Global Change Notification (GCN)

Product Family

GCN Number

Series image - Reference only

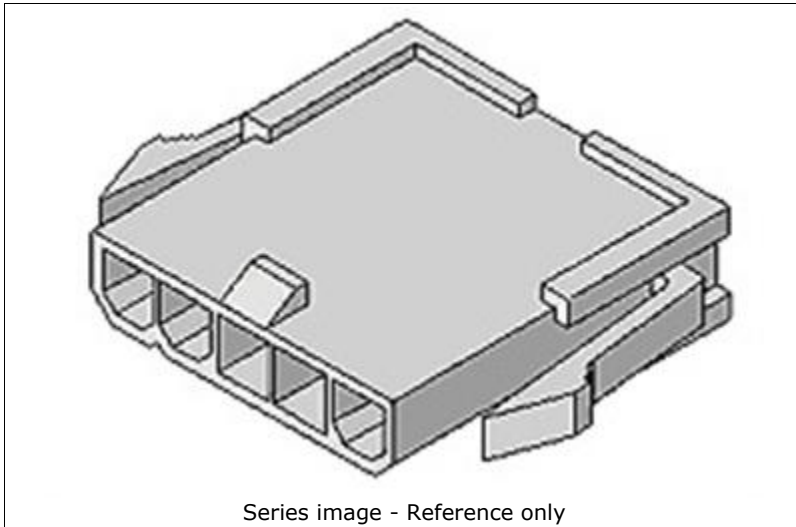
Change Description
